# DART SERVICE INSTRUCTION

TO AMEND INSTALLATION INSTRUCTIONS IIN-D350-689 REV. B

TO PROVIDE CUSTOMERS WHO HAVE PURCHASED D350-689-011/-021 DUAL HIGH BACK SEAT KITS WITH AN OPTIONAL D350-689-031 ARMREST/CONTROL GUARD KIT.

THE D350-689-031 ARMREST/CONTROL GUARD KIT REPLACES THE D350-689-019 CONTROL GUARD KIT, WHICH WAS FOUND TO BE INEFFECTIVE.

**FIGURE 1: Removal of D350-689-019 Control Guard Kit**

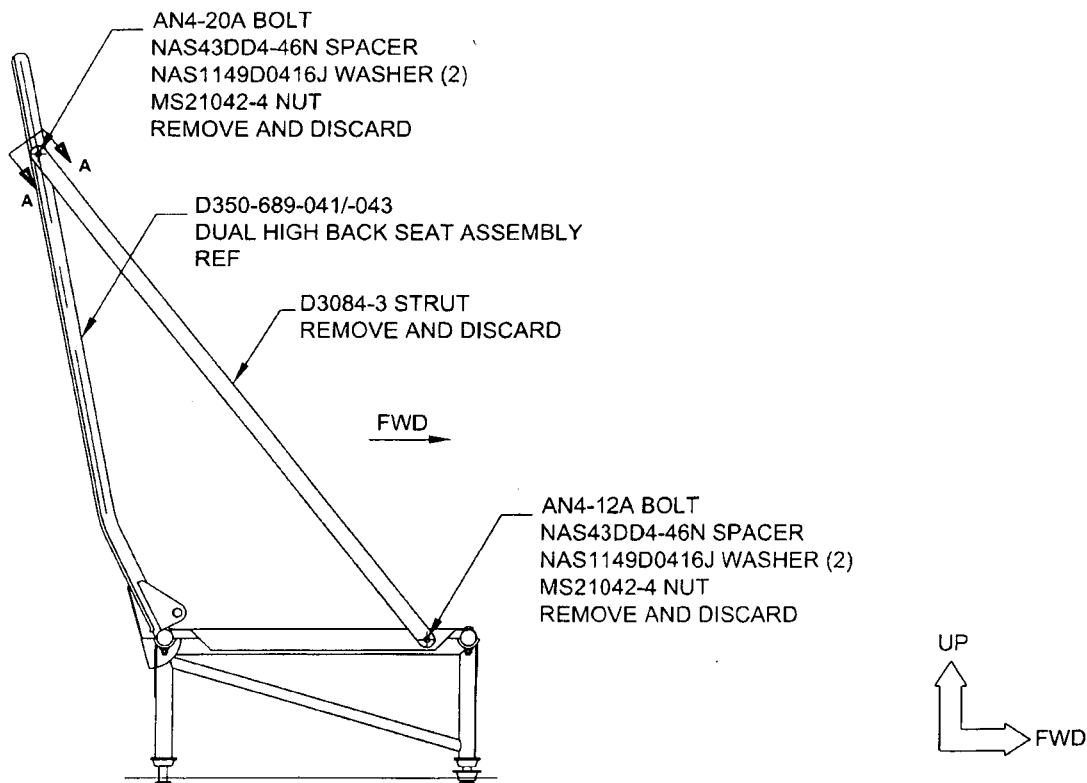
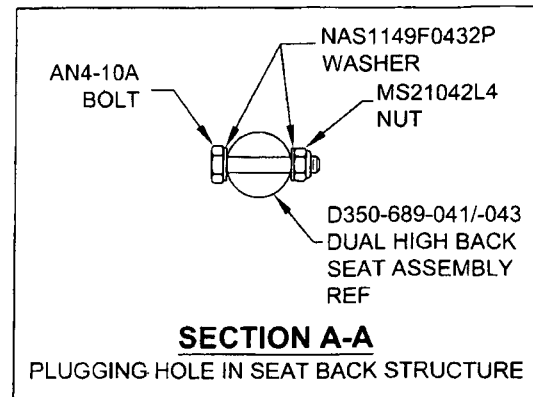
- 2) REMOVE THE D350-689-041/-043 SEAT IN ACCORDANCE WITH ICA-D350-689, SECTION 25.2 / 25.4.
- 3) FOR CUSTOMERS EQUIPPED WITH THE D350-689-019 CONTROL GUARD KIT, REMOVE AND DISCARD THE KIT. PLUG THE HOLE IN THE SEAT BACK STRUCTURE USING THE (1X) AN4-10A BOLT, (2X) NAS1149D0432J WASHERS AND (1X) MS21042L4 NUT PROVIDED IN THE D350-689-031 KIT AS SHOWN IN FIGURE 1.

**FIGURE 2: D350-689-031 ARMREST/CONTROL GUARD KIT**

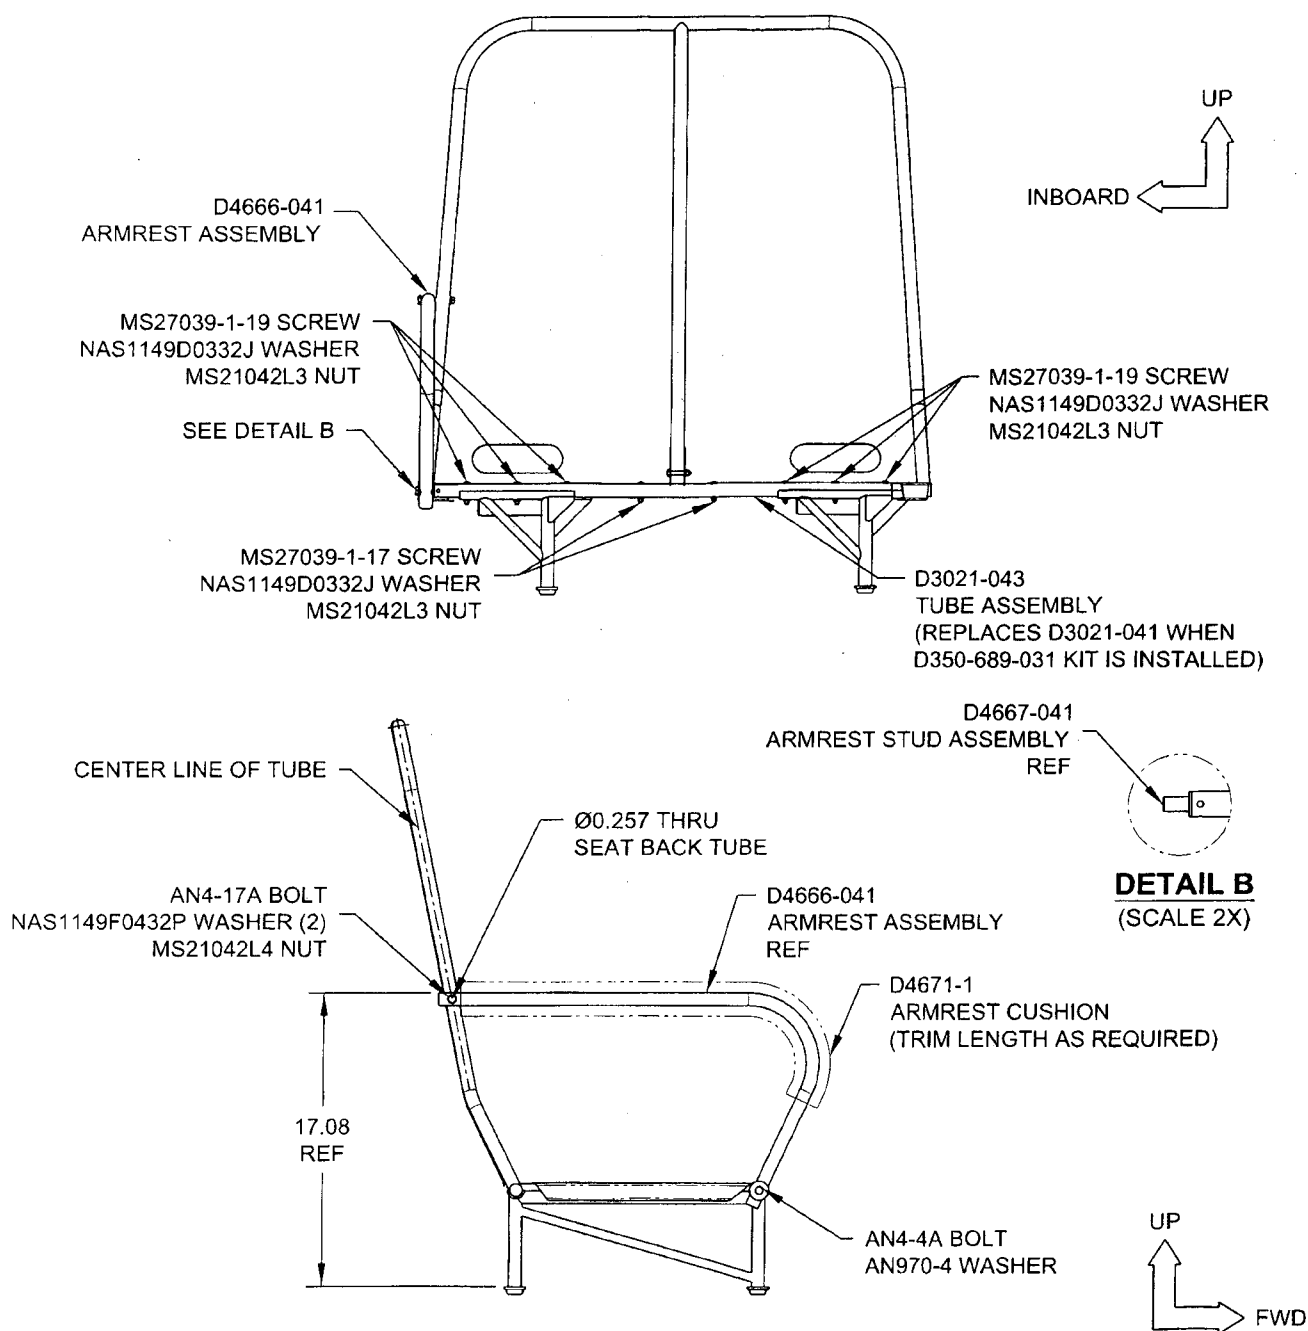
- 4) REMOVE THE D3021-041 TUBE ASSEMBLY FROM THE SEAT BASE STRUCTURE, BY UNFASTENING THE (6X) MS27039-1-19, (2X) MS27039-1-17 SCREWS, (8X) NAS1149D0332J WASHERS AND (8X) MS21042L3 NUTS AS SHOWN IN FIGURE 2. RETAIN THE HARDWARE IF SERVICEABLE.

- 5) REFERRING TO FIGURE 2: REPLACE THE D3021-041 TUBE ASSEMBLY WITH THE D3021-043 TUBE ASSEMBLY ENSURING THAT THE END WITH THE D4667-041 STUD ASSEMBLY FACES INBOARD. REINSTALL THE (6X) MS27039-1-19, (2X) MS27039-1-17 SCREWS, (8X) NAS1149D0332J WASHERS AND (8X) MS21042L3 NUTS. TORQUE FASTENERS TO 20-25 in-lb (2.3-2.8 Nm).

- 6) REFERRING TO FIGURE 2: INSTALL THE D4666-041 ARMREST ASSEMBLY ONTO THE SEAT BASE USING (1X) AN4-4A BOLT AND (1X) AN970-4 WASHER. INSTALL FINGER TIGHT. DO NOT TORQUE AT THIS TIME.

ROTATE THE D4666-041 ARMREST ASSY UNTIL THE HOLE AT THE AFT END OF THE TUBE ALIGNS WITH THE CENTER LINE OF SEAT BACK TUBULAR STRUCTURE. USING THE HOLE IN THE ARMREST AS A GUIDE DRILL Ø0.257 THRU THE SEAT BACK STRUCTURE.

INSTALL (1X) AN4-17A BOLT WITH (2X) NAS1149F0432P WASHER AND (1X) MS21042L4 NUT.

TORQUE AN4 BOLTS TO 50-70 in-lb (5.6-7.9 Nm).
